STAFF REPORT
Docket No. WS-106-22
Summary No.
Major Subdivision
Solarium Park

3840 Post Dr.; bounded by Woodmere Blvd., Lapalco Blvd. and Alex Kornman Blvd. (Figure 1)

Subdivision of
Lot C-3-B, Harvey Canal
Property into
46 lots, Solarium Park
Subdivision, dedication of
Solarium Loop and
drainage servitudes

FIGURE 4

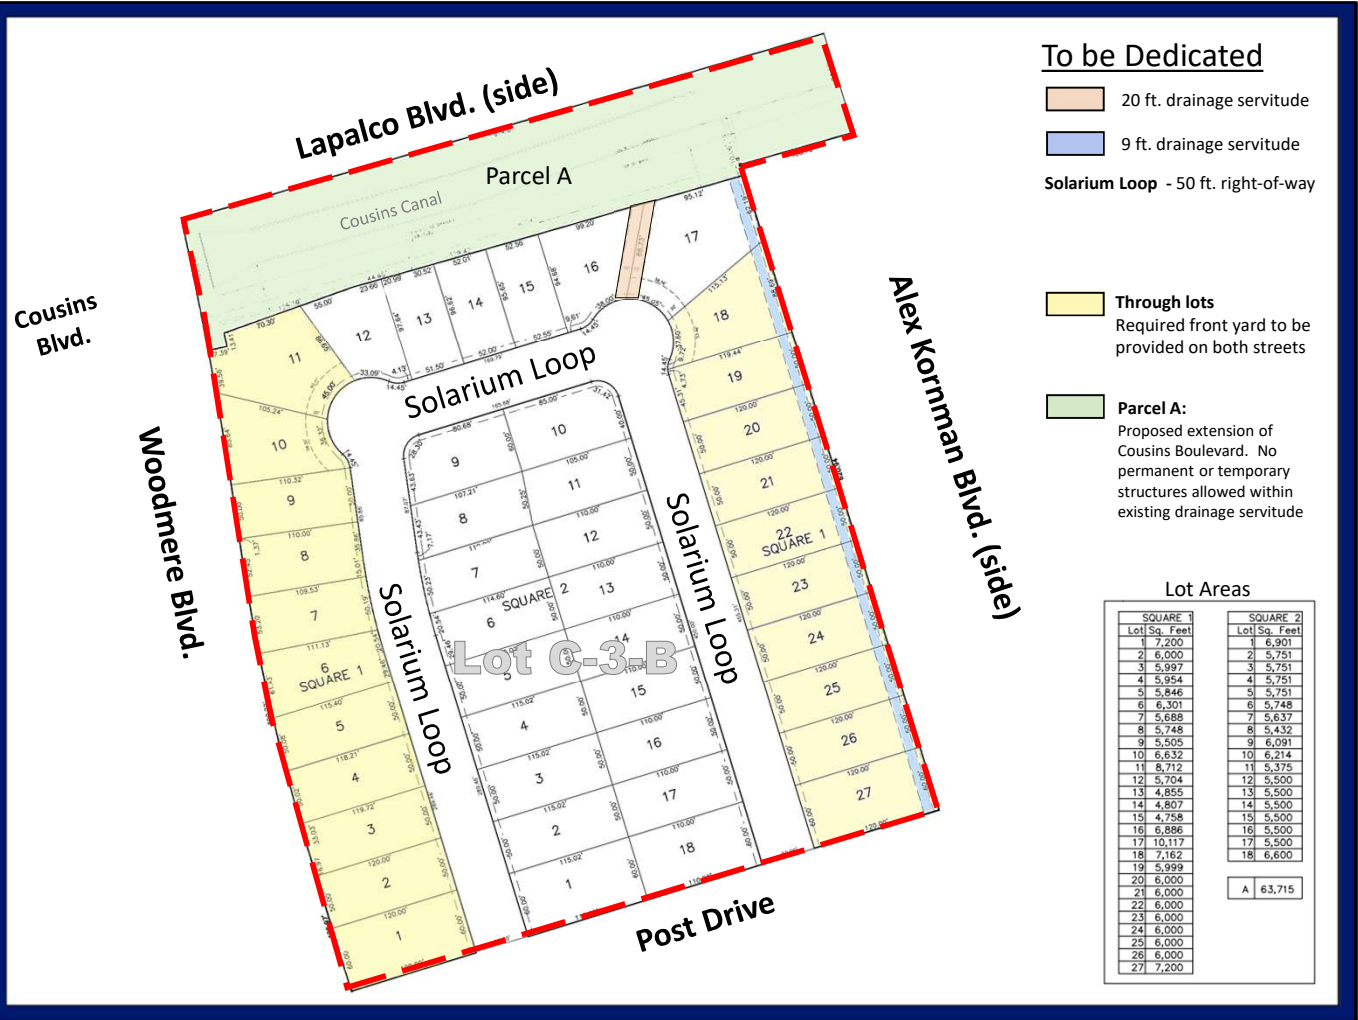
8. The GO-2 district requires a minimum lot width of 40 ft., depth of 75 ft., and area of 4,000 sq. ft. for development of single-family dwellings. Additionally, two-family dwellings require an area of 2,500 sq. ft. per family. The proposed lots, ranging in area between 5,000 and 10,117 sq. ft., meet the minimum lot width, depth, and area requirements of the GO-2 district for single- and two-family dwellings. According to the applicant, the property will be developed with single-family dwellings.

9. Proposed Lots 1 through 11, Square 1, Solarium Park, have frontage on Solarium Loop and Woodmere Blvd. Sec. 33-6.6.1 *Lots generally* states both lot frontages shall be front lines for setback purposes. As per the applicant, these lots will provide the required front yard on both streets. Additionally, lot access to and from Woodmere Blvd. will be prohibited.

Through lots
Required front yard to be provided on both streets

Parcel A:
Proposed extension of Cousins Boulevard. No permanent or temporary structures allowed within existing drainage servitude

FIGURE 5

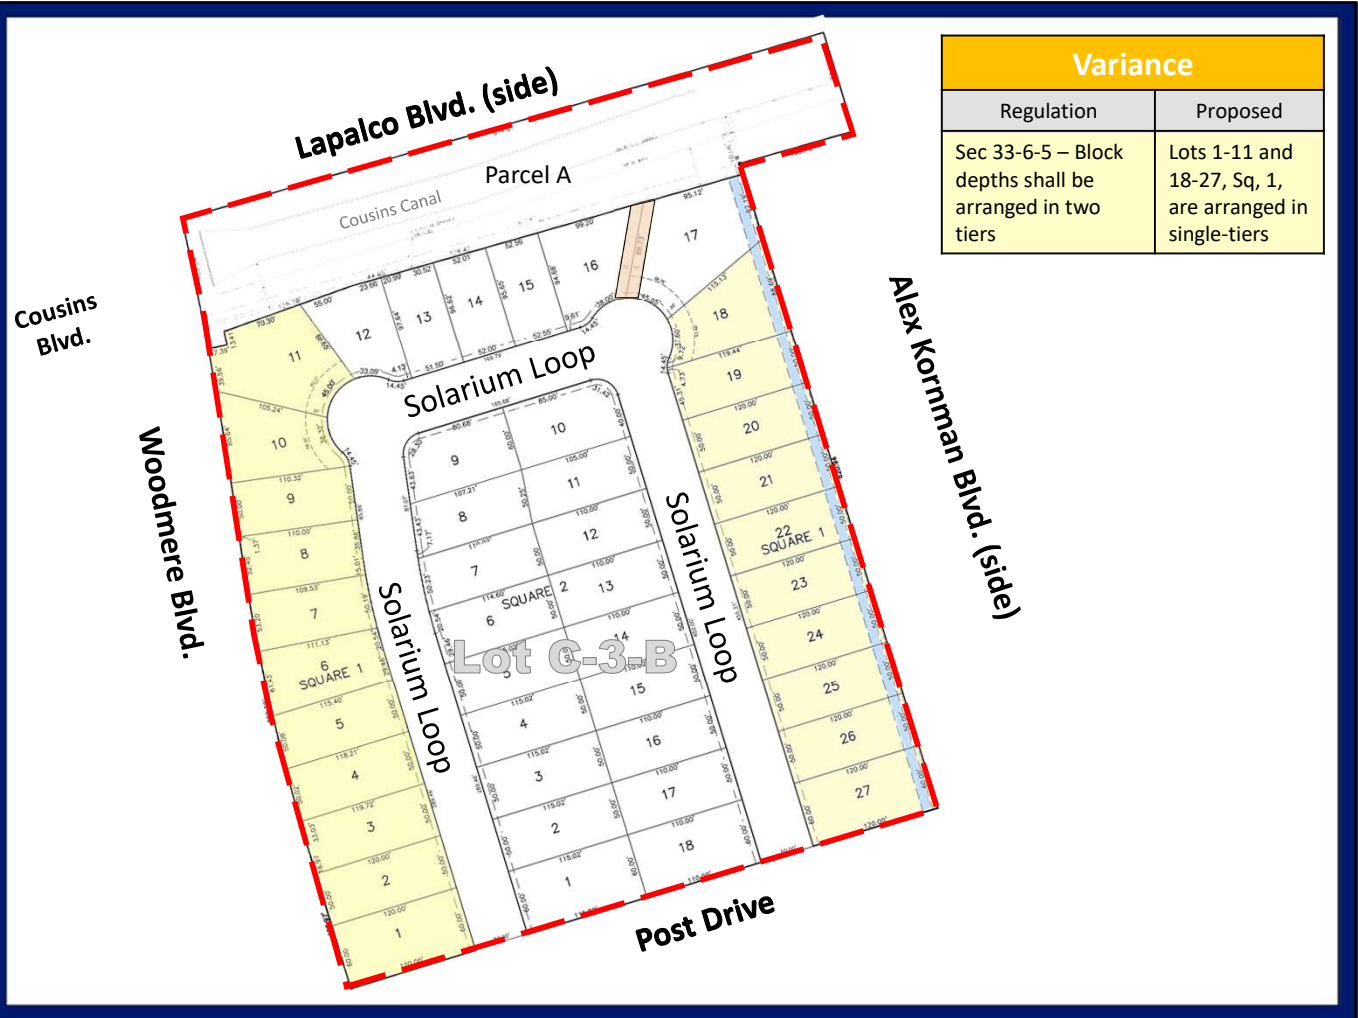
13. As per Sec. 33-6.5 *Block Standards* “the depth of the blocks shall be arranged to allow two (2) tiers of lots with utility servitudes, except where a single row of lots backs up to an interstate or arterial street, canal, river or railroad right-of-way.” The subdivision is designed with two (2) tiers of lots in the center with a single tier on the outer perimeter of the property. Proposed Lots 1 through 11, Square 1, back up to Woodmere Blvd. which categorized as a collector street and proposed Lots 18 through 27, Square 1, back up to abutting parcels; therefore, a waiver is required. With the exception of proposed Parcel A, which generally outlines Cousins Canal, existing Lot C-3-B has a square shape. The relative proportions of the existing lot, coupled with the minimum lot width and depth requirements, limit the potential block and lot pattern. Proposed Solarium Loop has a U-shaped design which incorporates a cross-street. The street has two (2) entrance and exit points allowing more evenly divided traffic flow within the proposed subdivision and onto Post Drive. The proposed block and lot pattern and street layout are consistent with the configuration of the existing lot; therefore, the requested waiver is appropriate. The findings outlined in Table 5 support the requested waiver.

| Table 4: Block and lot standards [Sections 33-6.5 and 33-6.6] | | |
|--|-------------------|---|
| Block Depth | No | The proposal does not meet the requirements set forth in Sec. 33-6.5 regarding block depth. The proposed block depth and proposed lot layout is reflective of the square shape of existing Lot C-3-B. |

| Variance | |
|--|--|
| Sec 33-6-5 – Block depths shall be arranged in two tiers | Lots 1-11 and 18-27, Sq, 1, are arranged in single-tiers |

| Table 5: Subdivision waiver required findings [Section 33-2.35] | | |
|--|-------------------|--|
| Property cannot be developed reasonably under the provisions of the Code | Yes | The waiver for block depth is appropriate due to the shape of existing Lot C-3-B and the proposed U-shaped street pattern. |
